**City of Urbandale  
Supplemental Specifications  
To Iowa Statewide Urban Design and Specifications  
Standard Specifications for Public Improvements – 2021 Edition  
January 2021**

URBANDALE STANDARD SPECIFICATIONS	REVISION 05-05-2020
	7030.101	SHEET 1 of 1
CONCRETE DRIVEWAY, TYPE A EXISTING PAVING, CURB GRINDING

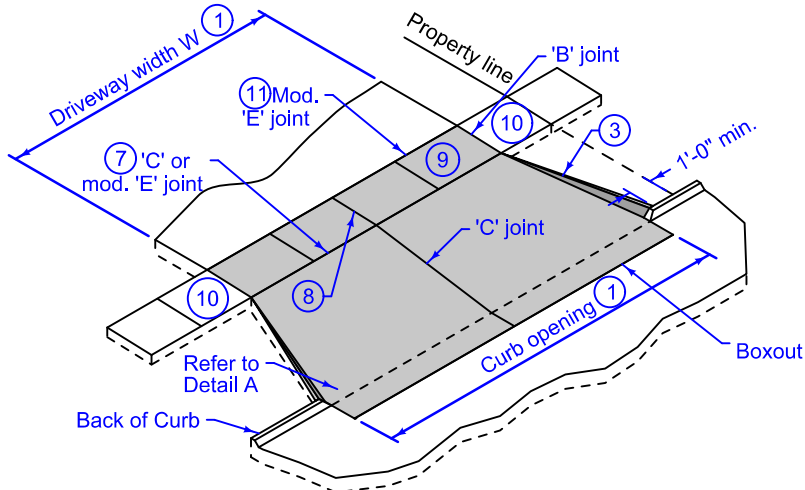
7	7030	7030.101	Replace with Urbandale Figure 7030.101
7	7030	7030.102	Replace with Urbandale Figure 7030.102

- ① Driveway width (W).  
Residential: 8 foot minimum, 24 foot maximum at sidewalk and at property line, 28 foot maximum at street.  
Commercial and industrial: As specified in the contract documents.

- ② Driveway radius (R).  
Residential: 10 foot minimum, 15 foot maximum.  
Commercial and industrial: As specified in the contract documents.
- ③ Transition the curb height to 0 inches at end of taper/radius or at the front edge of sidewalk. Do not extend raised curb across sidewalk.

- ④ Pavement thickness.  
Residential: 6 inches minimum.  
Commercial and industrial: 7 inches minimum.
- ⑤ Sidewalk thickness through driveway to match thickness of driveway.

- ⑥ Center reinforcing bar vertically in the pavement.
- ⑦ Match thickness of adjacent roadway, 8 inches minimum.
- ⑧ Provide 'C' joint when sidewalk and drive approach are both being built. Provide ½" 'E' joint when sidewalk is existing.

- ⑨ For alleys, invert the pavement crown 2% toward center of alley.
- ⑩ Target cross slope of 1.5% with a maximum cross slope of 2.0%. If specified in the contract documents, construct the sidewalk through the driveway 6 feet wide to serve as a passing space.

- ⑪ If cross slope of adjacent sidewalk panel exceeds 2.0%, remove and replace to transition from existing sidewalk to sidewalk through driveway. If elevation change requires a curb ramp, comply with SUDAS Figure 7030.206; verify need for detectable warning panel with Engineer.

- ⑫ Use ½" expansion joint material.

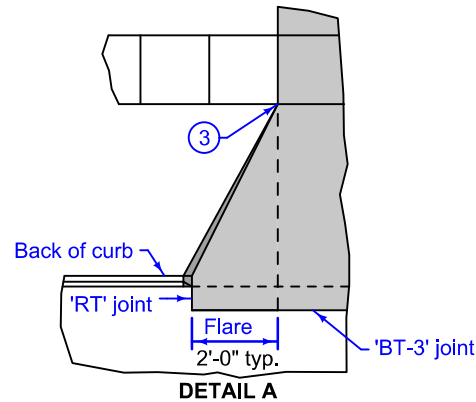
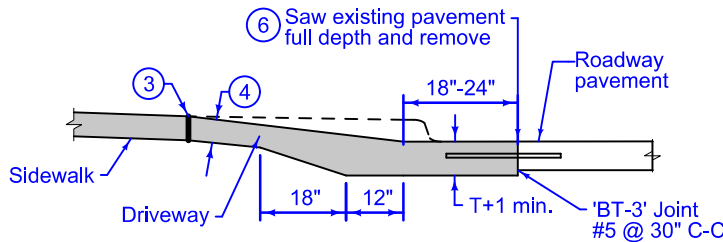
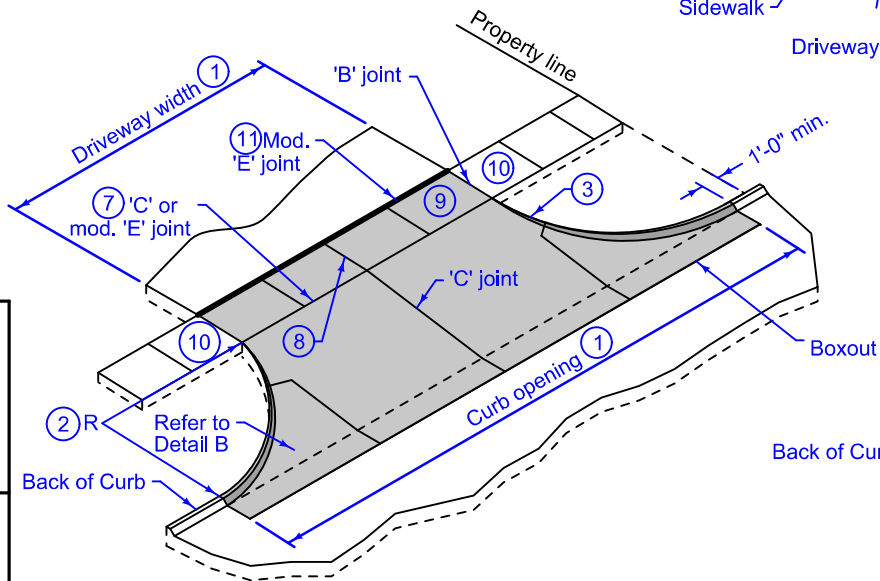
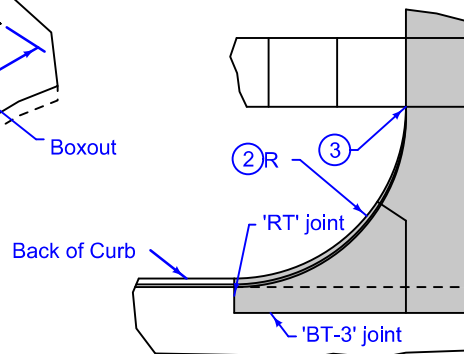
THIS DETAIL ONLY TO BE USED WITH PRIOR APPROVAL FROM CITY OF URBANDALE ENGINEERING DEPARTMENT.

- 1 Driveway width (W).  
Residential: 8 foot minimum, 24 foot maximum at sidewalk and at property line, 28 foot maximum at street.  
Commercial and industrial: As specified in the contract documents.

- 2 Driveway radius (R).  
Residential: 10 foot minimum, 15 foot maximum.  
Commercial and industrial: As specified in the contract documents.
- 3 Transition the curb height to 0 inches at end of taper/radius or at the front edge of sidewalk. Do not extend raised curb cross sidewalk.

- 4 Pavement thickness.  
Residential: 6 inches minimum.  
Commercial and industrial: 7 inches minimum.
- 5 Sidewalk thickness through driveway to match thickness of driveway.

- 6 If longitudinal joint is located 48 inches or less from the back of curb, extend boxout to joint line. Full depth saw cut is still required.
- 7 Provide 'C' joint when sidewalk and drive approach are both being built. Provide 1/2" 'E' joint when sidewalk is existing.

- 8 For alleys, invert the pavement crown 2% toward the center of the alley.
- 9 Target cross slope of 1.5% with a maximum cross slope of 2.0%. If specified in the contract documents, construct the sidewalk through the driveway 5 feet wide to serve as a passing space.

- 10 If cross slope of adjacent sidewalk panel exceeds 2.0%, remove and replace to transition from existing sidewalk to sidewalk through driveway. If elevation change requires a curb ramp, comply with SUDAS Figure 7030.205; verify need for detectable warning panel with Engineer.

- 11 Use 1/2" expansion joint material.
